3. Improvements to the Public Realm

April 29, 2022

Note: Language from the Board's draft of rules update is highlighted in yellow.

Figure xxx. Example of appropriate new alley repaving.

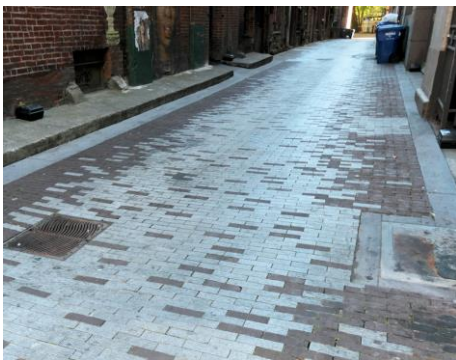
Commented [NG10]: Looking back at this it sounds confusing. Needs rewording

Commented [JO11]: ???

Commented [NG12R11]: PSB10015 is the Certificate of Approval number for approved installation at Nord and Pioneer Passage. It may be clearer to include the diagram and list the products approved. I will try to get those to you.

Commented [JO13R11]: Will make the changes when we get the PSB.

Figure xxx. Typical 3 globe pedestrian light fixture with bracket mounted traffic signal (left), 5 globe pedestrian light fixture at Pioneer Square Park (center left) Aladdin lamp streetlight (center right) and post top mounted traffic signal (right)

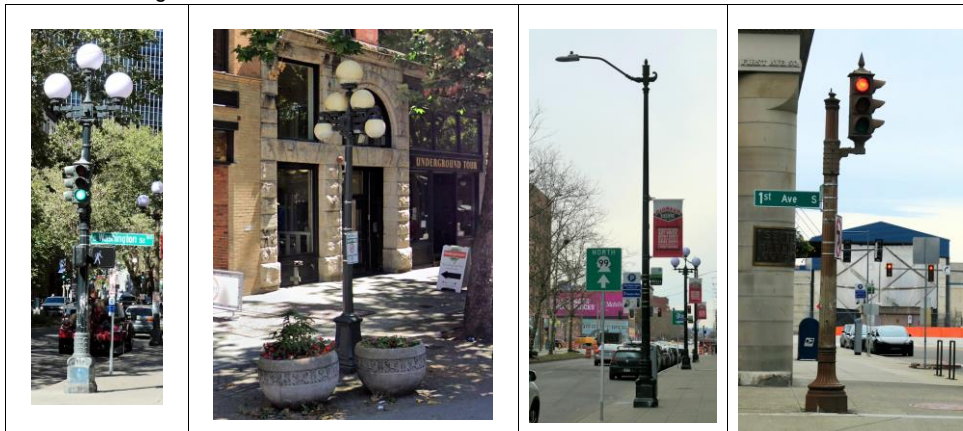
Commented [NG22]: Clarify traffic signals.

Commented [NG23]: I think that we need to add to the context that there are bronze Chief Seattle bases. I was also thinking about adding the history of the poles. 1908 the 3 globe and 5 globe with base shown in the photo of 5 globe below were used. The ones between the buildings and Pioneer Park are believed to be original. Then in 1925 the bronze bases were added. The three globe fixtures on the poles were replaced in the 70's but they are the same design as the original 1908 poles and bases remain from 1925. Many have been updated with new LED bulbs.

Commented [NG24]: Add Retain bronze Chief Seattle Bases bases. (some were filled with concrete and SCL says they are not salvageable.) Need to add to retain bronze and when replacement is found necessary by the Board they must be replaced with new bronze Chief Seattle Bases

Commented [JO25]: We will expand the figures to highlight the bases and better illustrate pole design.
